Response to Referee #1 (in blue)

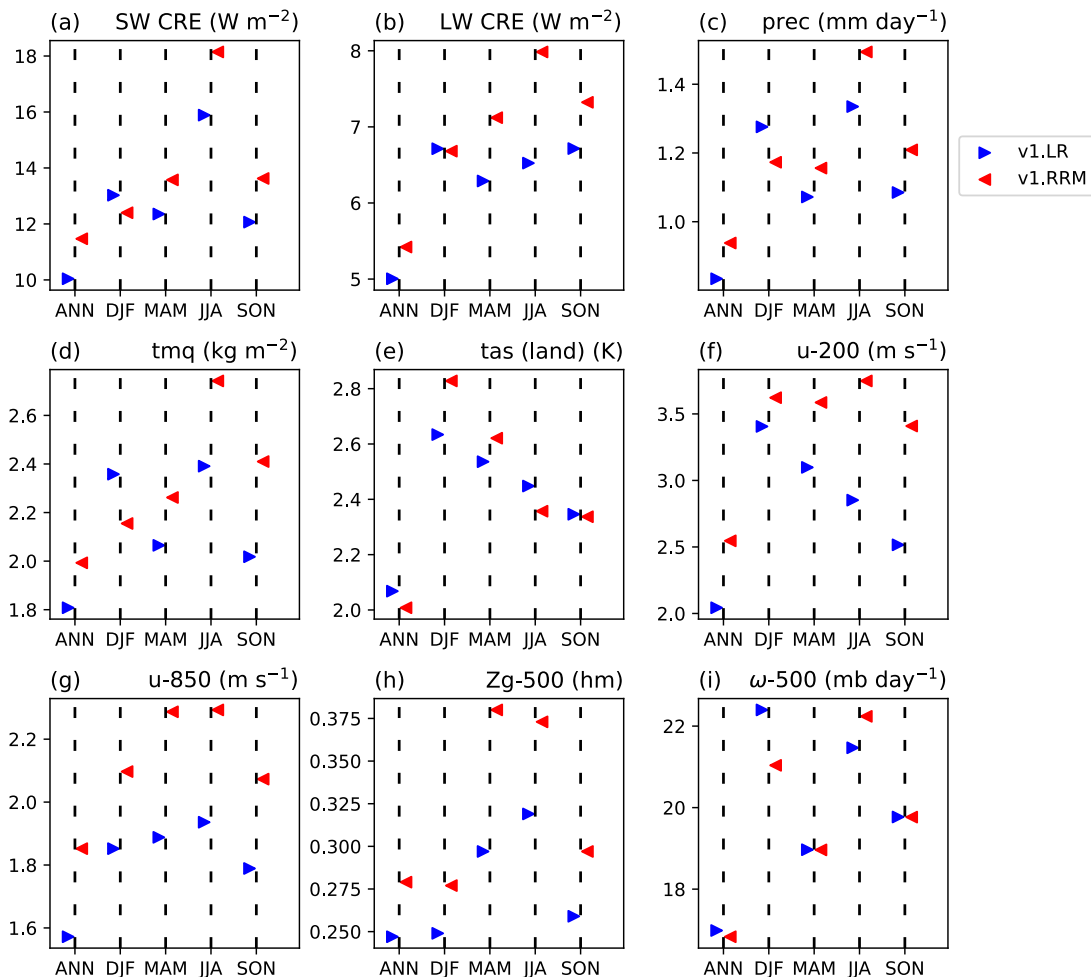
(a). Early on the authors develop “two criteria should be satisfied for the RRM to be widely adopted for global ESM releases: (1) reasonable global climate, and (2) minimal effort of retuning based upon the low-resolution counterpart.” It’s not clear what the authors mean in (2). They describe it as “Regarding (2), some physics parameterizations (e.g., deep convection) suffer from poor scale-awareness and hence require retuning as the model resolution increases (e.g., Xie et al., 2018). This implies significant model calibration efforts that may be unaffordable in addition to tuning the low-resolution model.” This last sentence stating that tuning may be unaffordable does not constitute a

The authors state that the usual practice of using a shorter physics time-step globally in RRM “cannot satisfy the two criteria above for the purpose of global climate production simulations mainly because the ZM deep convection scheme and other cloud parameterizations used by EAM are by design not scale-aware (Xie et al., 2018).” Here begins a pattern throughout the paper of conflating scale-awareness with time-step awareness in the cloud schemes. (2) is not a true criteria, and is more of a statement that it will take additional resources if you want to tune the physics at the shorter-physics time-step to produce a reasonable climate, i.e., criteria (1). The justification authors provide that they didn’t tune because the physics aren’t scale-aware does not make sense, as they are still running non scale-aware physics, just with a longer time-step. In many places throughout the paper they refer to how this hybrid time-step strategy is responsible for the success of satisfying both criteria. And then they also make statements like at line 678 where they say the hybrid time-step “bypasses the persistent poor scale-aware problem of atmospheric physics in a multi-scale framework,” which is just not true.

For v1, we have tuned models at both low-resolution (100 km) (Golaz et al., 2019) and high-resolution (25 km) (Caldwell et al., 2019). The figure below shows the global spatial root-mean-square-error (RMSE) results from the v1.LR (blue triangles) and the v1.RRM (red triangles) with high-resolution grids over the CONUS and both physics parameters and

timesteps tuned for high-resolution (see details in Tang et al., 2019). It is clear that the v1.RRM results are generally worse (larger RMSE) than the v1.LR results. This is the main reason why we didn't choose this approach for the NARRM in E3SMv2.

We included this v1 figure as Fig. A2 in the revised version and clarified this in Section 2.1. It now reads as “Furthermore, even if NARRM used the retuned high-resolution physics parameters along with the shorter physics timestep, we would still have degraded global simulation quality over the LR model (see Fig. A2 for the EAMv1 results).”.

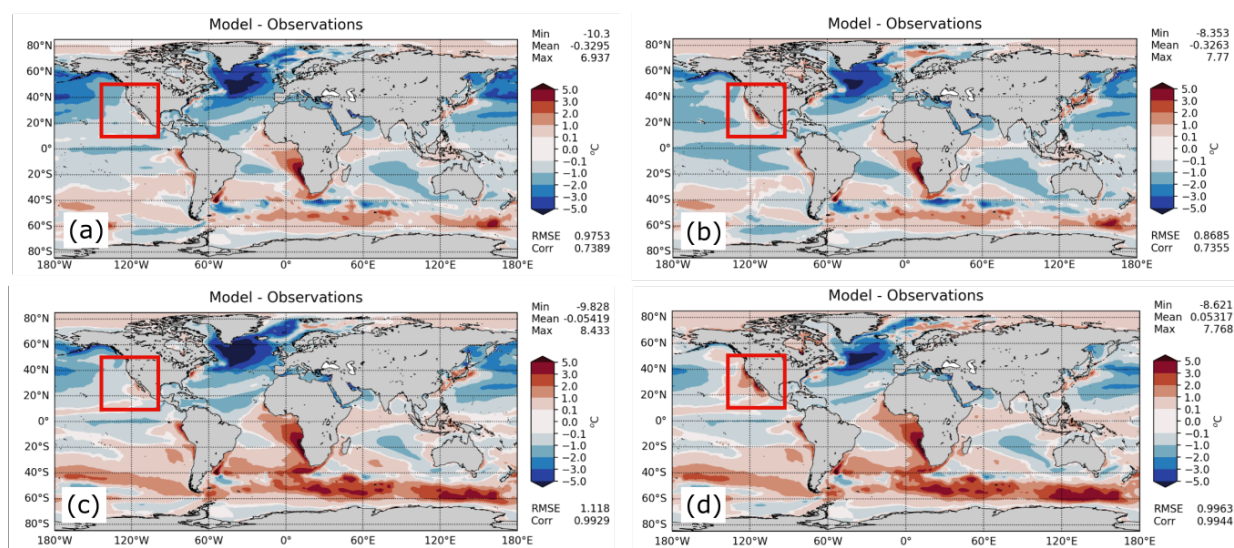
Line 358. “highlights the advantage of coupled RRM over a single-component RRM ...” How can you conclude this? You are not comparing to RRM AMIP, you are comparing to LR coupled. In RRM AMIP, you can easily select to have a high-resolution coastline, and the ocean grid is nominally on the RRM grid.

We agree that the evidence for benefits of the coupled RRM is not clear from just looking at fully coupled low resolution and fully coupled NARRM. A deeper analysis of the benefit of the fully coupled RRM is conducted in a companion paper nearing submission by Van Roekel et al. To clarify this point we have added one new figure, which is reproduced here.

All figures show the difference between modeled SST and the HadISST dataset. Panel (a) is the fully coupled RRM, (b) is the fully coupled LR simulation, (c) couples the RRM atmosphere to the LR ocean, and (d) the LR atmosphere couples to the RRM ocean.

In the stratus region near California (red box), we see that the SST bias is greatly reduced in the coupled RRM relative to the coupled LR. Panels (c) and (d) show that the high-resolution atmosphere is primarily responsible for the reduction in bias. However, if the bias in panel (c) is compared to (a) the fully coupled RRM further reduces the bias, suggesting resolution improvements in both components improve the coastal SST bias.

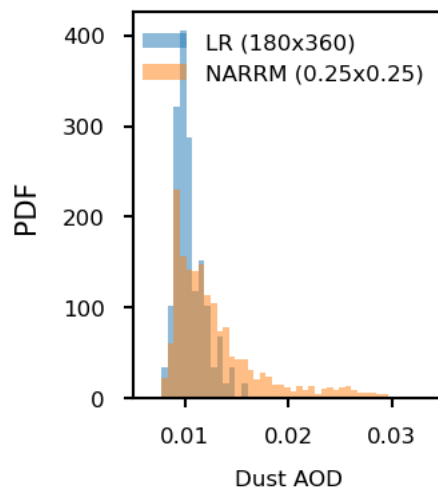
Figure 16. I suspect this increase in AOD would survive remapping to a common grid before computing the histogram, but I still think this should be done to make it a more apples-to-apples comparison.

Figure 16 (now Fig. 18 in the revised manuscript) indeed compares the two model simulations (LR and NARRM) of dust AOD on a common grid: 0.25x0.25. This is now clarified in the text:

Also clarified in the Figure 18 caption: “Calculated probability density function (PDF) of the dust AOD predictions from LR (0101) and NARRM (0101) between 2000--2014 remapped to the same 0.25 deg grid resolution, over the major dust source region in US ...”

For completeness, we plot the dust AOD pdfs from LR and NARRM in their original resolutions below, which is similar to the original Fig. 16 (now Fig. 18 in the revised manuscript):

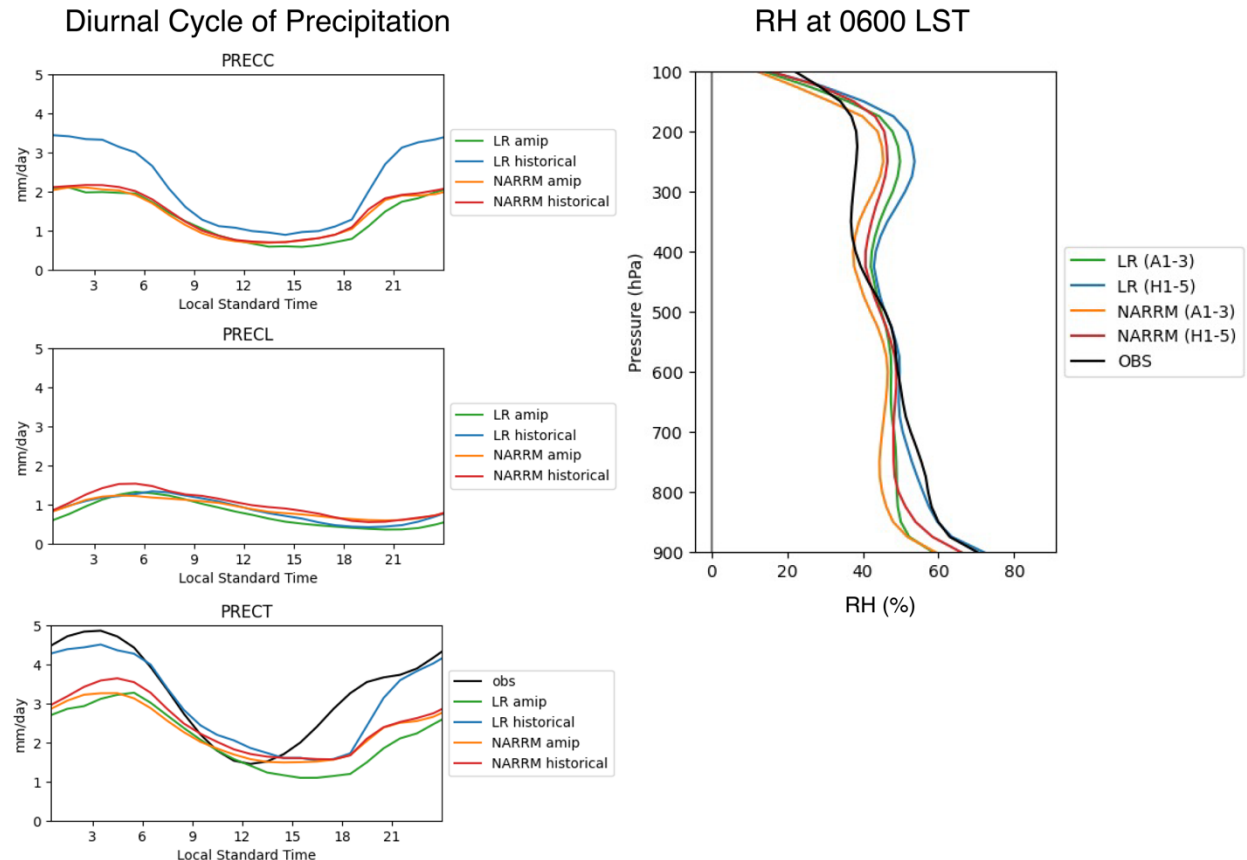
Section 5.3. Why are the latent heat fluxes larger in LR(H1-5), and has systemically lower LCL on clear-sky days? Does NARRM introduce a dry bias in the atmosphere?

To explore why the latent heat fluxes are larger in LR (H1-5), here, we examined the summertime diurnal cycle of precipitation (shown below). During the daytime (0900-1800 LST), the precipitation distribution is similar across all four versions of model simulations. However, the nighttime precipitation is better in LR (H1-5) as compared with ARM observation, which is mainly attributed to the increased convective precipitation. The early morning RH profile also confirms a much moister lower and upper atmosphere in LR (H1-5). As a result, the LCL is much lower in LR (H1-5) compared to other model versions. The SST may also play a role for the performance of the coupled run with interactive ocean/ice, i.e., LR (H1-5). Further analysis is needed to fully resolve this question, which is beyond the scope of this study.

The warm and dry bias over the central U.S. is one of the common issues in weather and climate models. As shown in the mixing diagram (Fig. 32 in the revised manuscript), the surface is still warm and dry for all models on clear-sky days. NARRM does not introduce an additional dry bias in the atmosphere. It seems the impact of resolution is generally minor on the land-atmosphere coupling based on this study, however, we still need to look into the nighttime precipitation performance in LR to resolve the puzzle.
